Bottoms Gallery (Pvt) Ltd.

Bulbul Tower, Dighir Chala, Chandana, Gazipur
(23.994592, 90.382016)

11th May 2014

Flat slab at Level 4

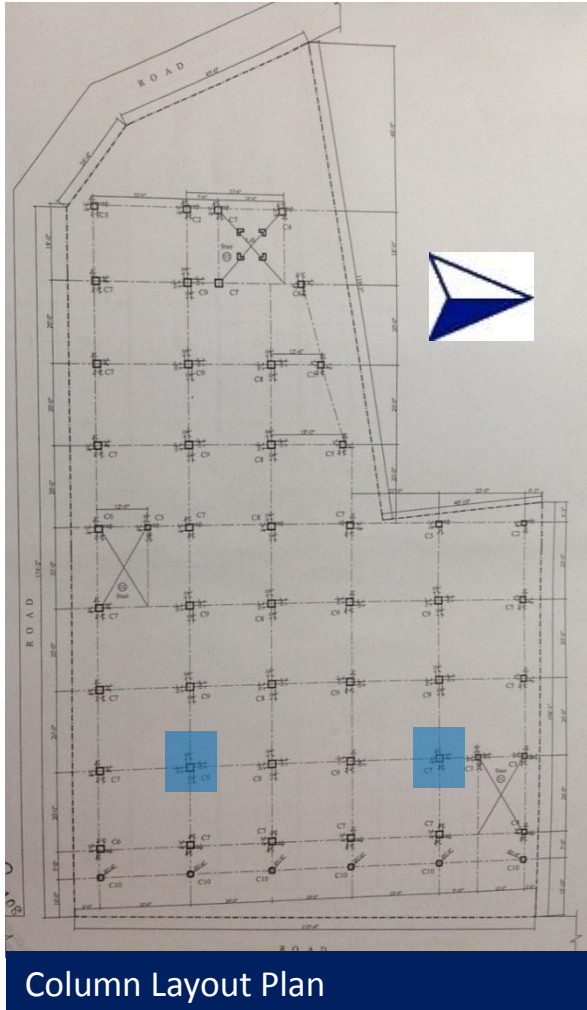
Punching shear in flat slabs requires immediate action

- Flat slabs were observed at all levels, some of which were subject to storage loads.
- There were no shear links referred to in the drawings.
- Detail Engineering Assessment required to determine capacity of slab with regard to punching shear.

Internal Column detail at Basement

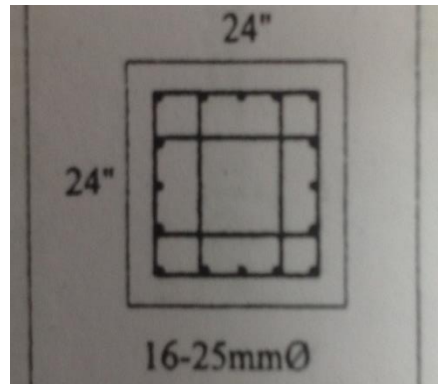
- Cursory calculations indicate that the working stresses to the Basement columns are highly stressed.

- Grade 60 steel is called up in the structural drawings. The reinforcement quantities recorded at Basement level using the Ferro-scanner appeared to coincide with the values provided in the Column Schedule.
- Brick aggregate was observed in the Basement columns in lieu of the specified stone aggregate.
- No loading plan was provided for the building. From inspection, the critical columns support garment and fabric storage, toilet slab build-up on levels one to six and water tanks at roof level.
- The building was originally approved by Rajuk as a 10-storey industrial building.

Column aggregate type

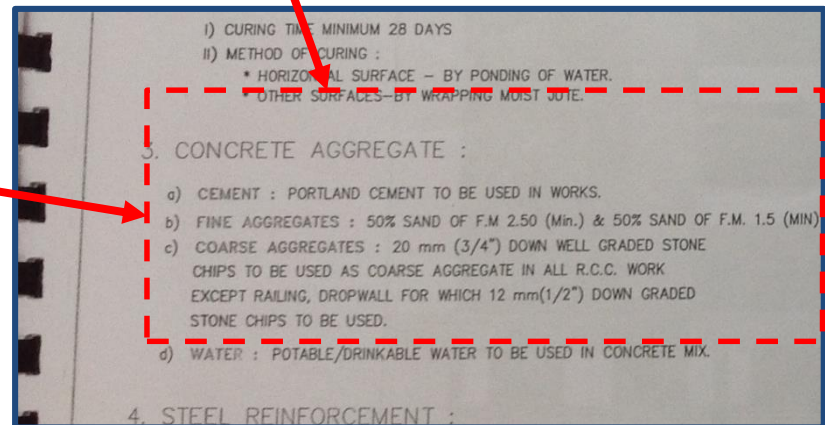
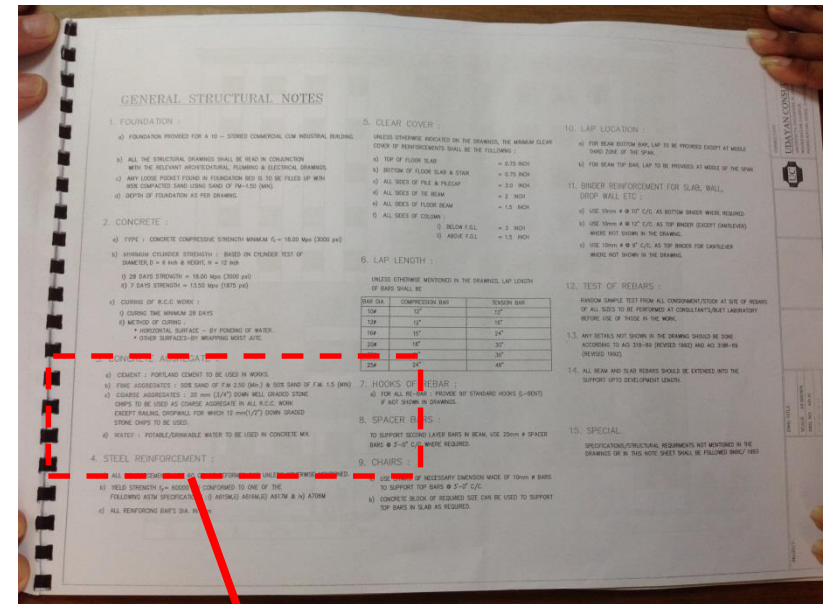
Stress levels in columns require immediate action

Design drawings indicate stone aggregate concrete was to be used. Basement columns opened up clearly show concrete contains brick aggregate

Location of garment storage on 2nd to 6th floors

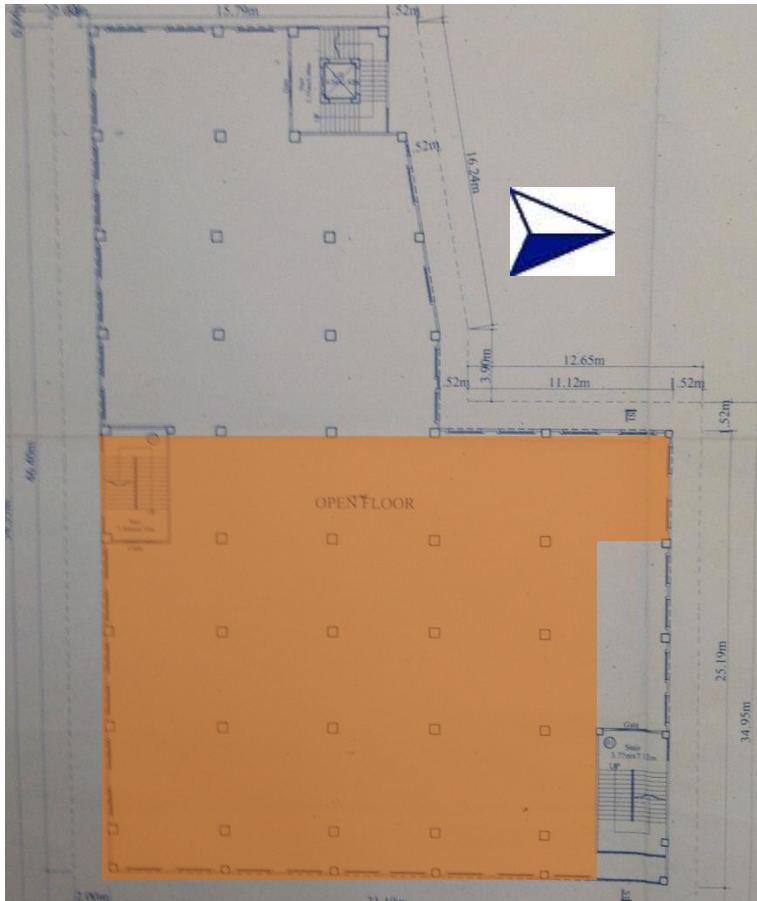
The floor load management system was incomplete as no loading plans were observed for any of the levels. Garment storage was present on 2nd to 6th floors, and fabric storage was present on 1st floor.

Location of fabric storage on 1st floor

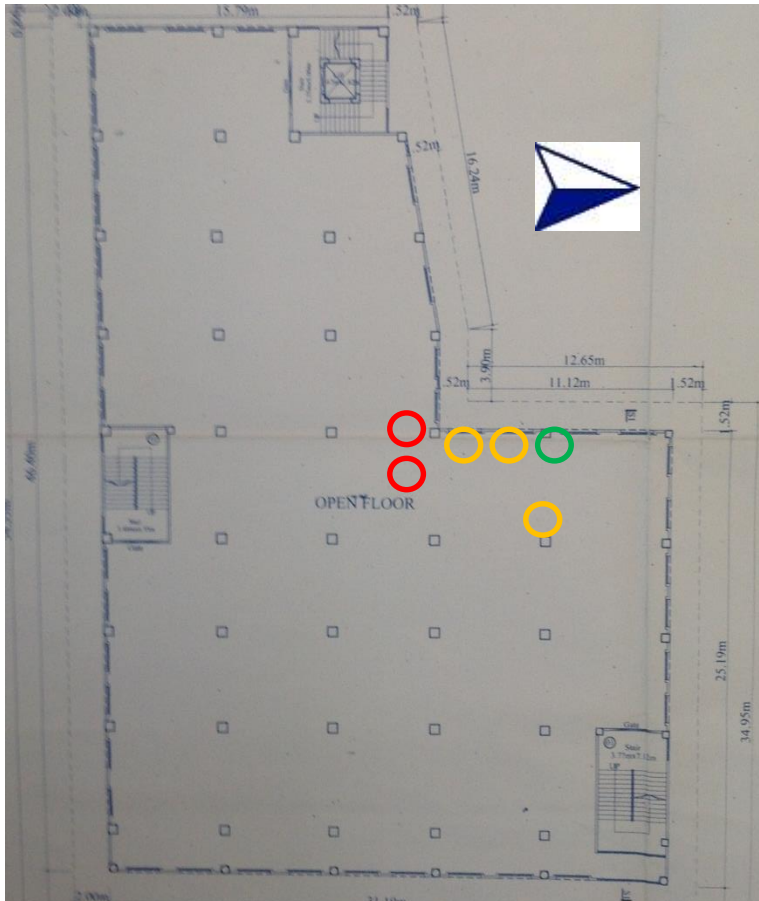
Storage for rolls of fabric was present on 1st floor.

Location of water tanks on 7th floor (current roof)

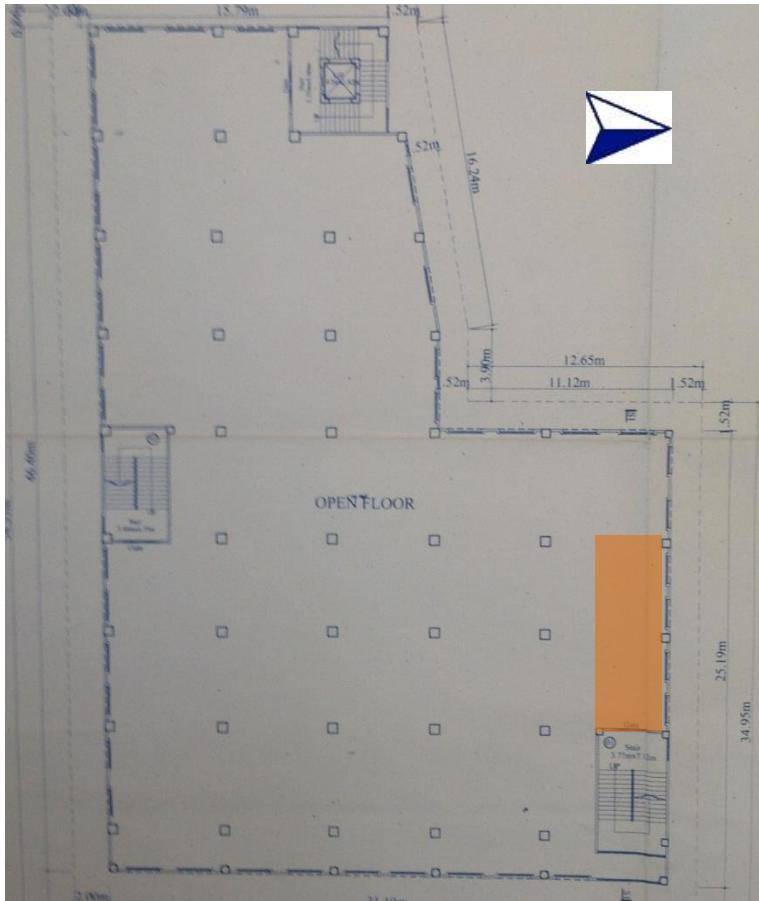
- Six water tanks were observed at 7th floor (roof). The combined capacity of these tanks is 17,500 litres.
- In addition, a 2000 litre tank is located in a plant room on the Ground Floor.

Location of toilets on 1st to 6th floors

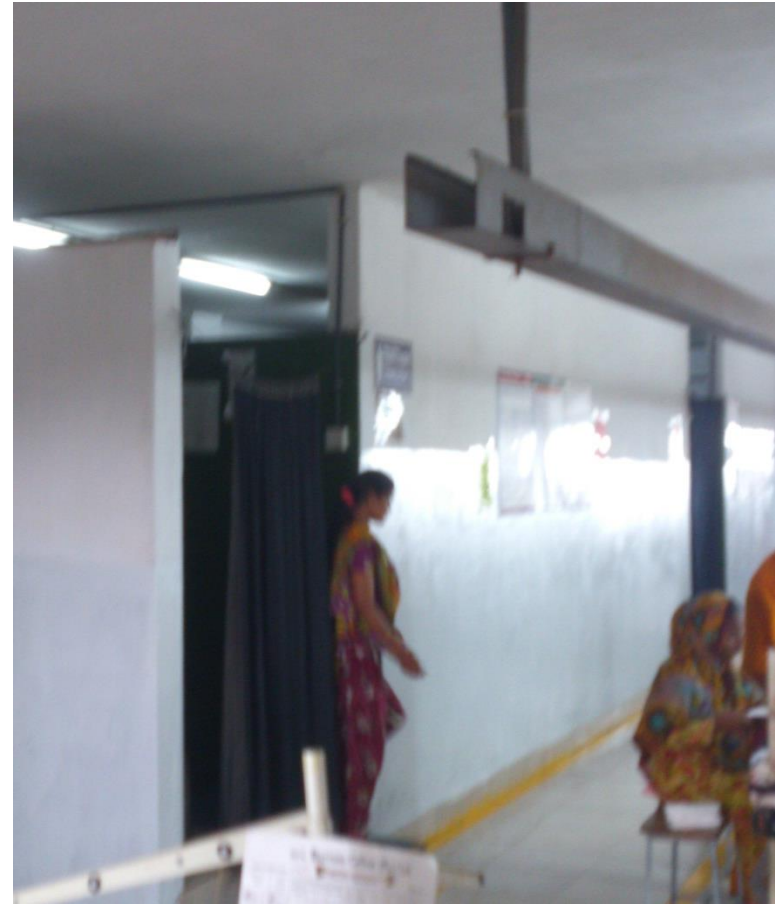
- Slab build up was present in the toilet areas.
- The average build-up depth observed was 308mm.

Location of brick wall partitions on Ground Floor

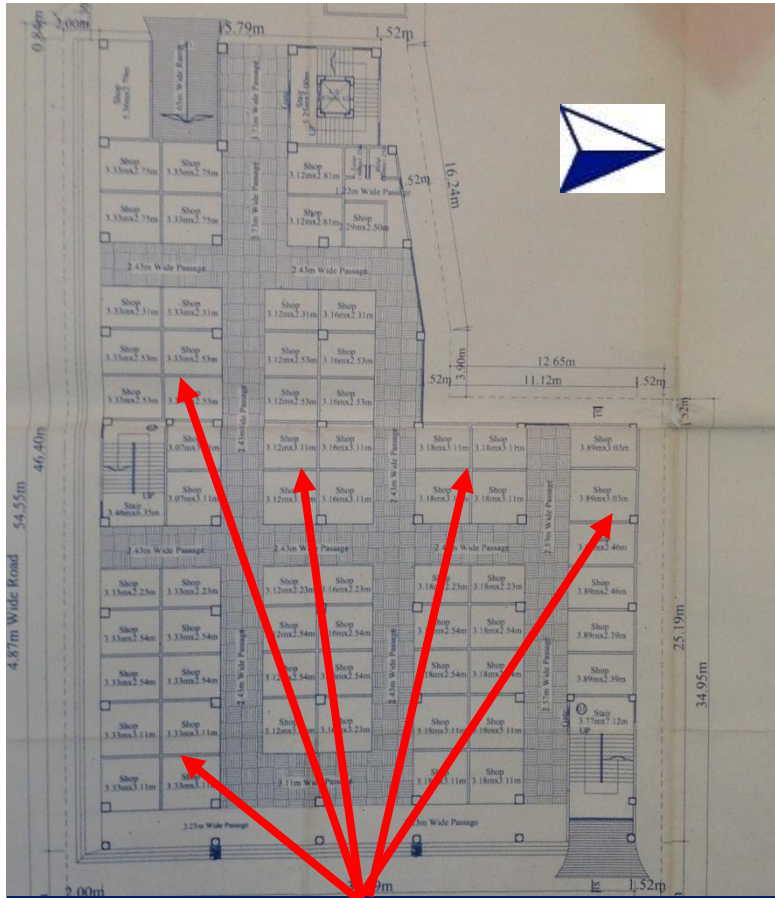
Heavy weight brick partitions were present on the suspended ground floor.
Demolition of these walls had commenced, and the resulting rubble was observed on ground floor.

General arrangement for 1st to 7th floors with a 212mm flat slab on columns. No shear walls are indicated.

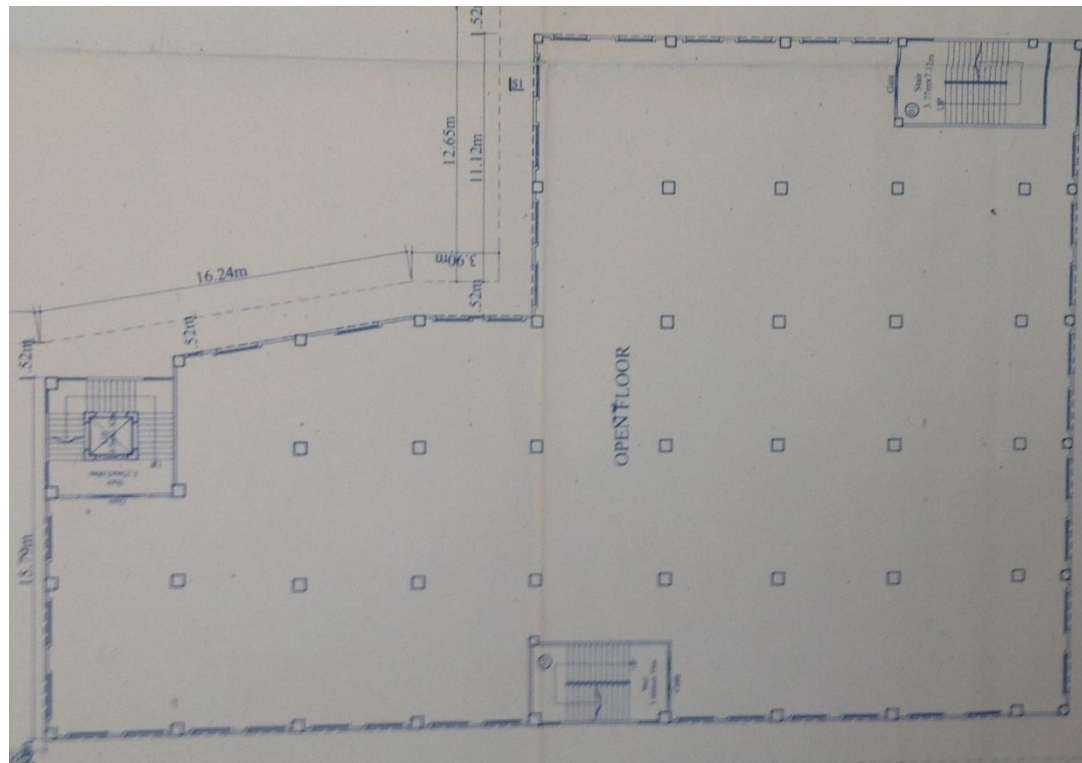
- The lateral stability system to the building is unclear.
- The structural system of the building is flat-slab construction with no drop panels at the column location. There are no shear walls indicated on the provided drawings.
- It is assumed that the lateral stability of the structure is provided through frame action between the slabs and the columns.
- Building Engineer to carry out a lateral stability analysis of the building and provide the necessary remedial works for lateral stability if required.
